QUESTIONS & ANSWERS
Updated June 26, 2024

RFP #AAHC-24-05
Broadway Terrace Renovations

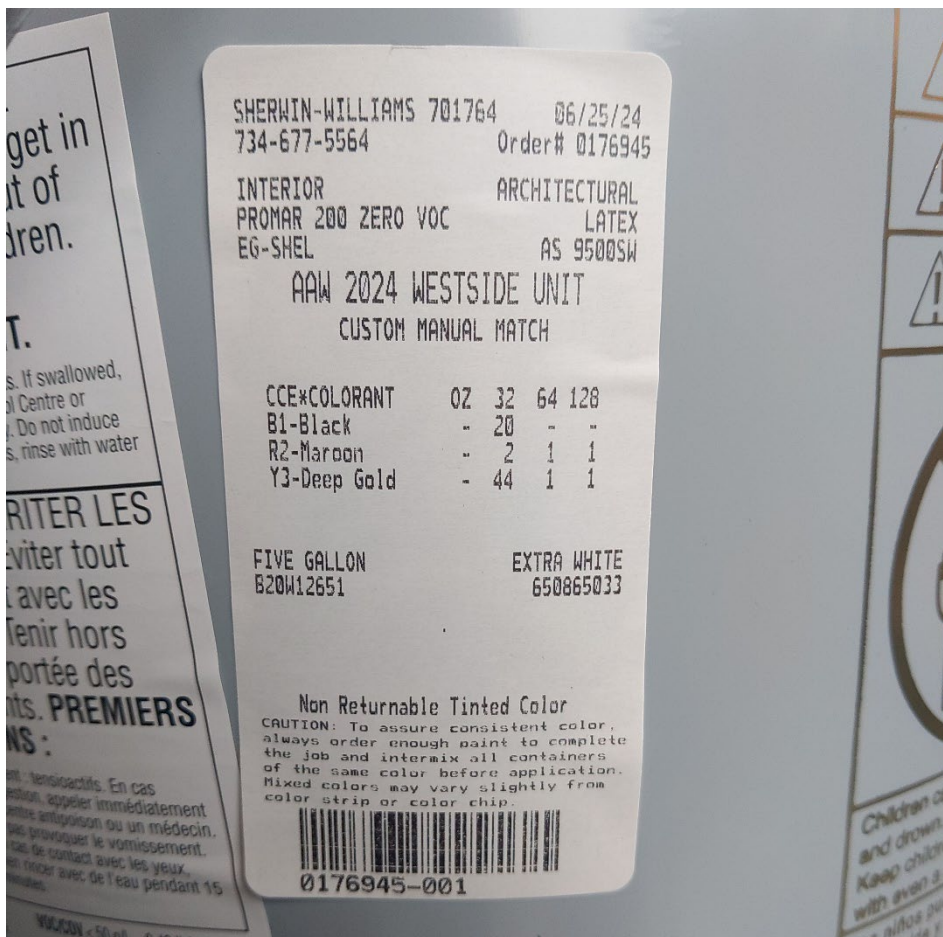
Question 7) The included specifications have 2 paint colors; wall paint, and trim paint. All ceilings are called to be painted, is it the same as the wall color / sheen or will they be selecting another color / sheen for the ceilings?

Answer: There will be one color and it will have the same sheen. Please see below for the Sherwin-Williams paint specifications being used at all AAHC properties.
